Access Compliance Report

Public Rights-of-Way

(Island Curb Cuts)

Intersection ID: 51491	Main Street: N_TRYON_ST	Cross Street: INSTITUTE_CR	Location: NW
ADA ID: 44AA13848D28	Curb Cut Type: MedianRefuge2	Initial Pass/Fail: Fail	Overall Compliance: No
Codes/Mitigation Info/Possible Solution		Field Measurements/Component Compliance

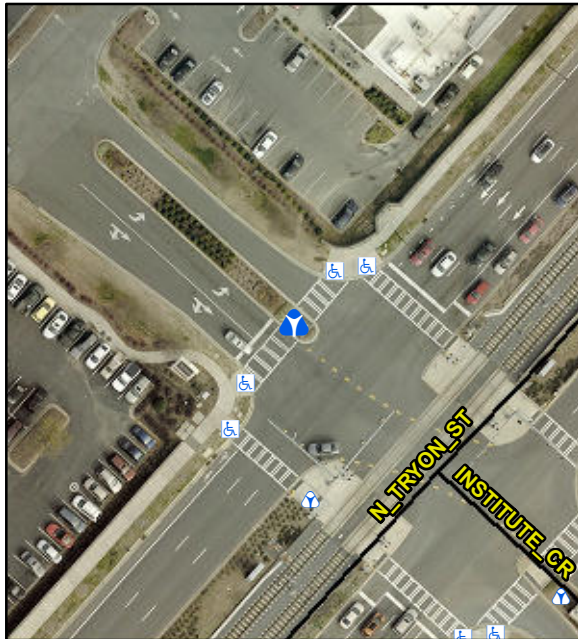
Remove & Replace Entire Refuge.
Remove & Replace Gutter.

Compliance	Description	Data	Compliance	Description	Data
Yes	Refuge 1 Length (In)	72.0	Yes	Gutter 1 Ponding?	N/A
Yes	Refuge 1 Width (In)	90.0	No	Gutter 1 Lip Ht (In)	2.5
Yes	Refuge 1 Slope (%)	4.7	No	Gutter 1 Slope (%)	N/A
Yes	Refuge 1 X Slope (%)	2.2	No	Gutter 1 X Slope (%)	N/A
N/A	Painted X Walk1?	No	N/A	DWS 1 Provided?	N/A
N/A	X Walk 1 Direction	To NE	N/A	DWS 1 Contrast?	N/A
N/A	X Walk 1 Width (In)	N/A	N/A	DWS 1 Length (In)	N/A
N/A	Road 1 Slope (%)	0.5	N/A	DWS 1 Full Width?	N/A
N/A	Road 1 X Slope (%)	4.3	N/A	DWS 1 Offset (In)	N/A
Yes	Refuge 2 Length (In)	72.0	Yes	Gutter 2 Ponding?	N/A
Yes	Refuge 2 Width (In)	90.0	No	Gutter 2 Lip Ht (In)	2.5
Yes	Refuge 2 Slope (%)	4.2	No	Gutter 2 Slope (%)	N/A
Yes	Refuge 2 X Slope (%)	1.5	No	Gutter 2 X Slope (%)	N/A
N/A	Painted X Walk2?	No	N/A	DWS 2 Provided?	N/A
N/A	X Walk 2 Direction	To SW	N/A	DWS 2 Contrast?	N/A
N/A	X Walk 2 Width (In)	N/A	N/A	DWS 2 Length (In)	N/A
N/A	Road 2 Slope (%)	4.0	N/A	DWS 2 Full Width?	N/A
